The following are our comments on the subject applications. This email supercedes my previous email to Andy P with my comments (email date Thurs, Apr 2, 2020, 12:14pm). Some comments changed, I edited the format, and removed the email chain. See you all at the 11am TRC virtual mtg.

**Subject:** Applications for 8,10,12 & 18 Colby Farm Lane

**LAYOUT & LANDSCAPING PLAN**

8, 10, 12, & 18 COLBY FARM LANE  
NEWBURYPORT, MASSACHUSETTS

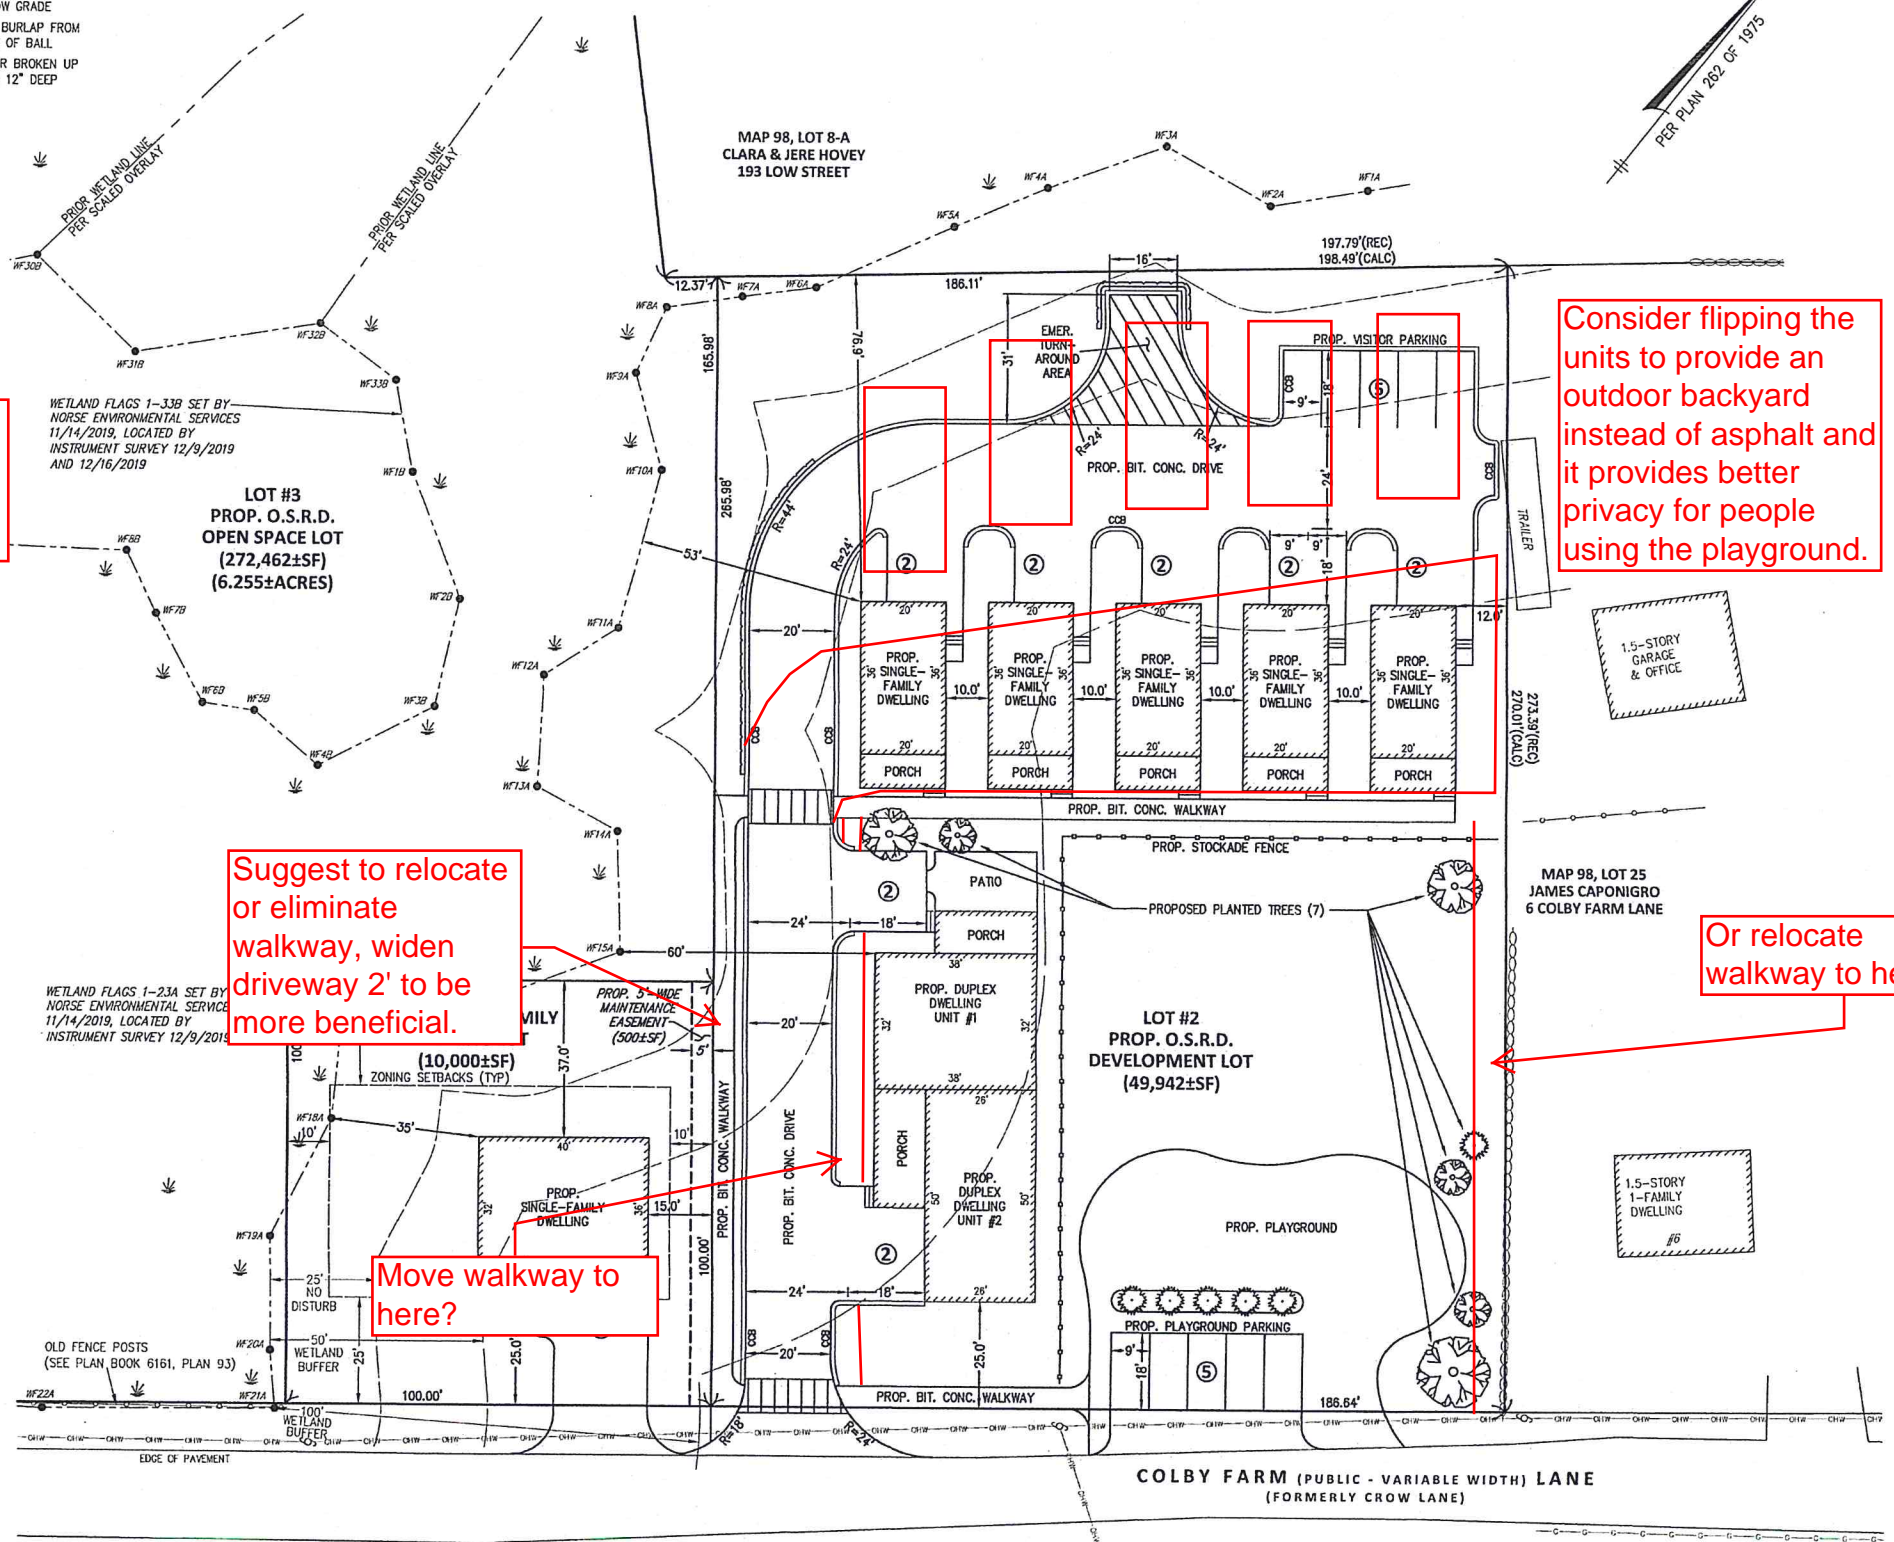
- It is highly likely that the walkway on the west side will never be used. People will walk down the driveway. This seems like an unnecessary amount of pavement and materials and reduces show storage areas. Suggest relocating as redmarked or do not install at all.

- 20' foot driveways are very narrow, especially at the entrance and the 90-degree turn where two cars won't be able to pass simultaneously. Widening 2'-4' would help.

- Suggest making the walkway public and placing in the ROW. Also suggest adding a piece of sidewalk to the east/right of the playground parking to the property line in case the street ever gets a sidewalk built.

- The pavement of Colby Farm Lane is in very bad shape in this area and has an inconsistent pavement width. Suggest having it improved so the entrances for this project can meet new roadway pavement and so the entrances don't have to be realigned in the future. (Colby Farm Lane appears to need widening in this location, which will impact these entrances. I have no opinion on who should pay for this improvement, but it should be done so it's well-coordinated.)

Suggest to relocate or eliminate walkway, widen driveway 2' to be more beneficial.

Consider flipping the units to provide an outdoor backyard instead of asphalt and it provides better privacy for people using the playground.

Or relocate walkway to here

Move walkway to here?
